RE: Response to Information Request (s13.2 DA Rules)  
Development Permit for Reconfiguring a Lot (1 into 1 Lot plus new road)  
202 Gardner Road, Rochedale QLD 4123 - A006738631

# Response to Information Request

Figure 1: Extract of approved plan DA105, Rev 04 of A005747839

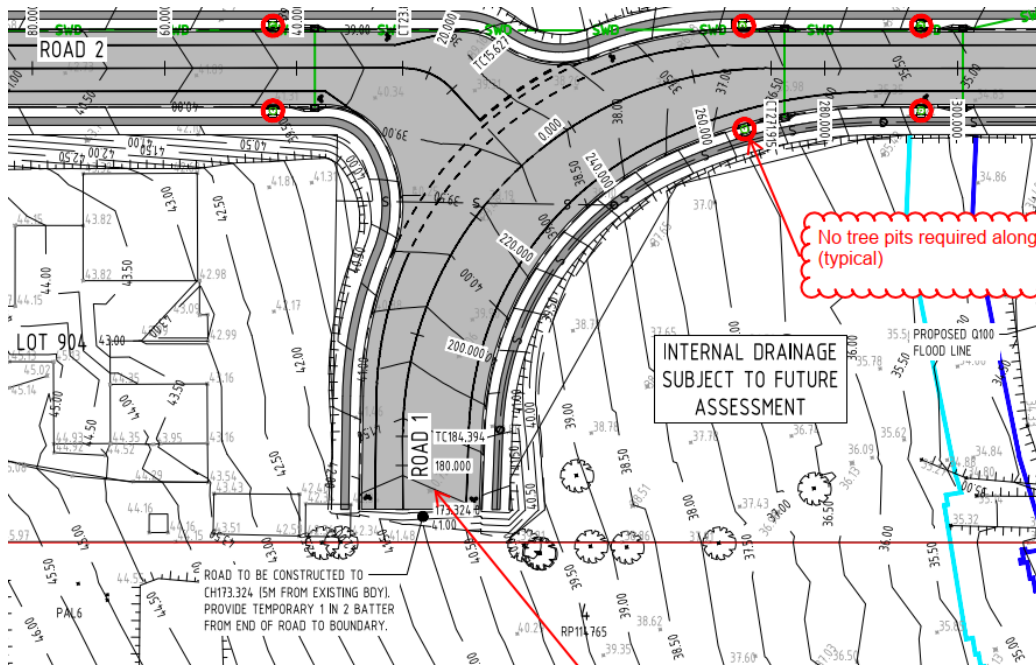
The purpose of the inclusion is to ensure that the construction of the new district road neatly ties into the already-approved section of the road (under Council approval A005747839) immediately to the north. As shown in **Figure 1** below, (which is an extract of approved plan DA105, Rev 04 of A005747839), the approved road was not designed to abut the southern boundary of 198 Gardner Road to ensure that the road's development footprint did not encroach into 202 Gardner Road, as it was not part of the application. Considering that the design of the district road has now been finalised, the intent is to include 198 Gardner Road in this application to demonstrate how the two applications will tie in together and the road will be seamlessly constructed.

Figure 2: Extract of Proposed Subdivision at 198 & 202 Gardner Road (Council Reference: A006761597)

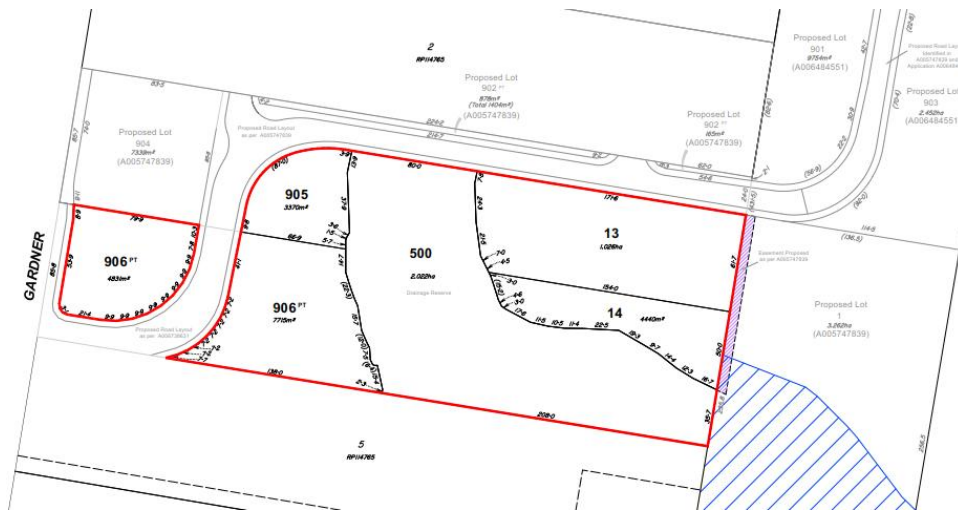
- iii) An easement for overland flow purpose is required over the creek flooded area in the balance land.
  - iv) Proposed stormwater within the new road cannot cross the road from gully to gully. Gullies are to connect to manholes and drainage under the road pavement as per the Infrastructure Design PSP (Chapter 7 Stormwater Drainage).

The purpose of this development application is to facilitate trunk road infrastructure only. The proposed road connection is located wholly outside of the waterway corridor.

A separate development application has been lodged over land at 198 & 202 Gardner Road for a Development Permit for Reconfiguring a Lot - 2 into 5 Lots (including 2 development lots, a drainage lot and 2 balance lots) (Council reference: A006761597). This concurrent development application seeks to reconcile and realign the mapped waterway corridor in accordance with the Flood Impact Assessment approved as part of Council approval A005747839. Under the concurrent development application, the drainage reserve / waterway corridor will be located on its own lot (Proposed Lot 500) and is intended to be dedicated to Council for drainage purposes (shown in **Figure 2** below). As such, it is requested that Council indicate (amendment in red) on any approved plans the location of the required easement. As this land remains under assessment as part of other development applications, it is critical for our client that this land is not put under any environmental covenant or be dedicated until the other applications have been decided.
